Accessibility Design Review Report

Project Title: Light Horse Interchange Warehouse Facility (Lot 7)
165 Wallgrove Road & 475 Ferrers Road, Eastern Creek

Job Number: 22195

Report Version: 22195_ADR_SSDA_v1.1

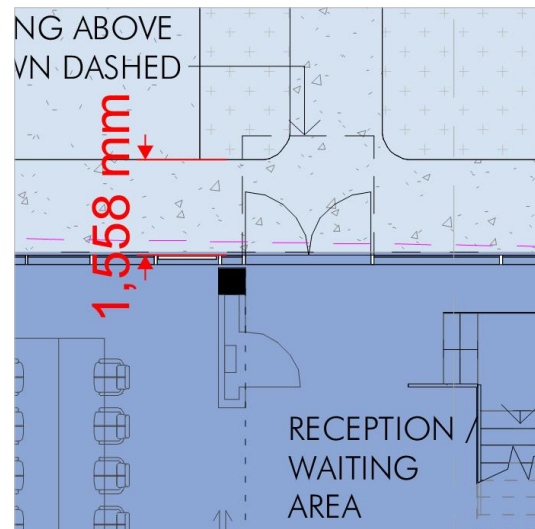
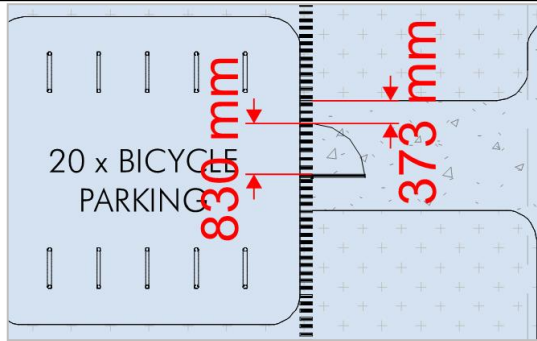
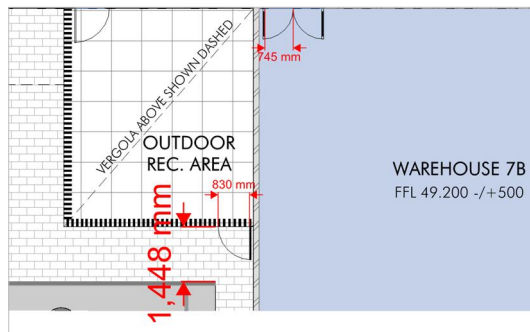
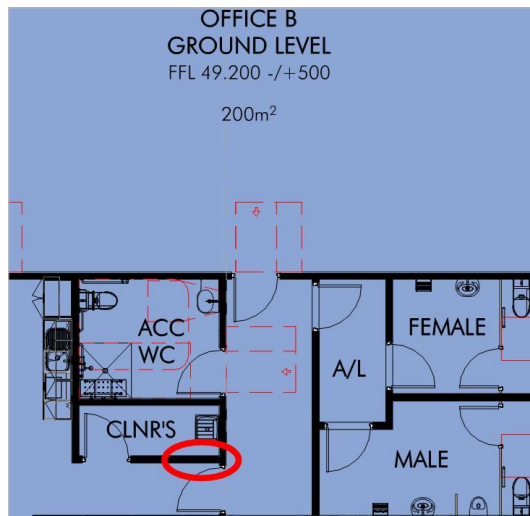
Compliance Departures:

(1670mm required)

(530mm required)

(530mm required unless both are automated)

(1670mm required)

(530mm required)

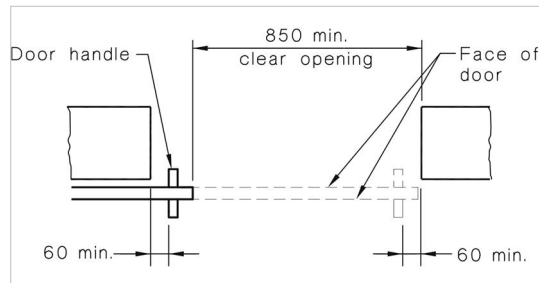
Ensure hardware circulation space of 60mm either side is provided to sliding doorways in the open/closed position. This generally requires an active leaf cavity/clearance of 1000mm.

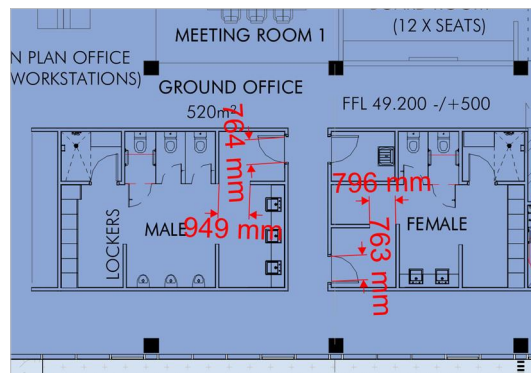
Ensure all swipe card readers/push buttons are installed >500mm from a corner and between 900mm - 1100mm from the FFL

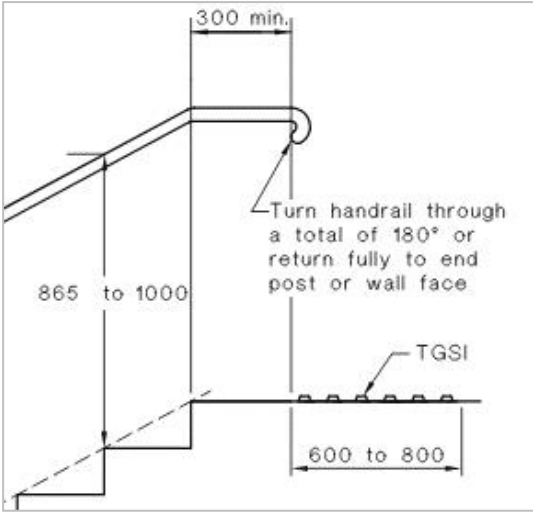
Compliance Departure:

Confirm if a pedestrian pathway links the 2x offices/buildings and how access is achieved.

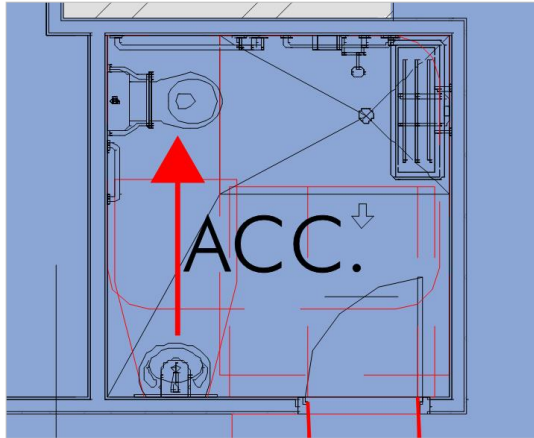
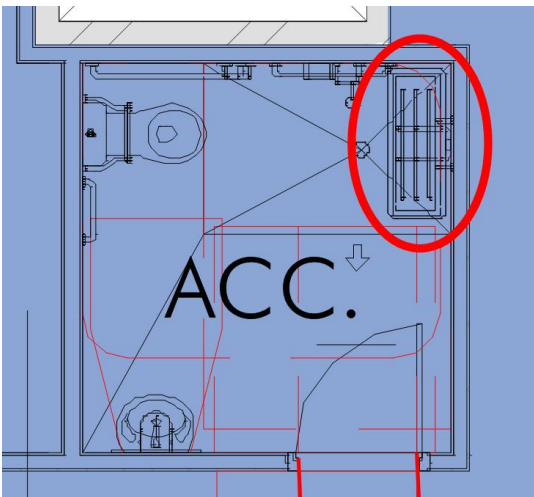
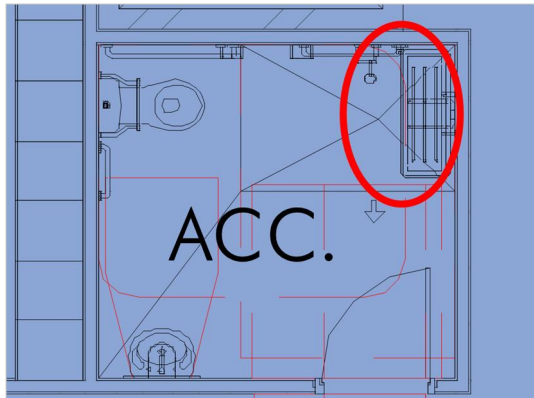
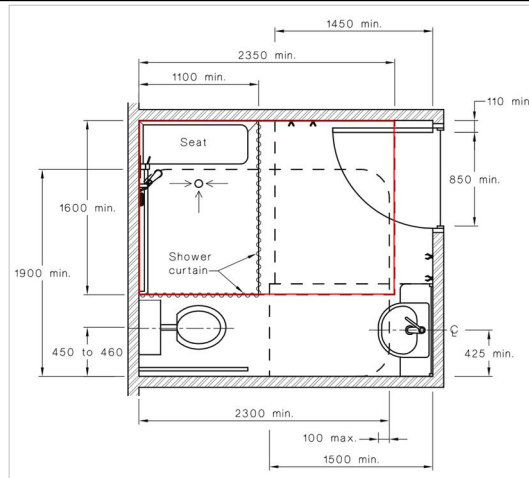
Compliance Departures:

The 7A GF shower seat appears to slightly intrude into the pan circulation space and the Level 1 seat fully intrudes into the circulation space. Consider using AS1428.1-2009 configuration.

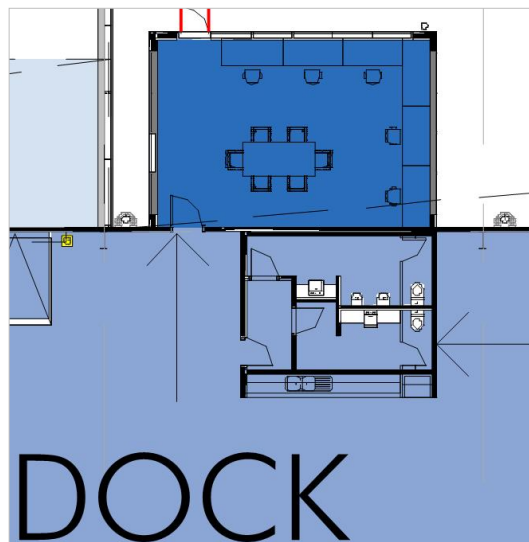
An accessible unisex sanitary compartment may be required in association with the Dock Office bank of toilets. Refer to D3.4 comments for further information.
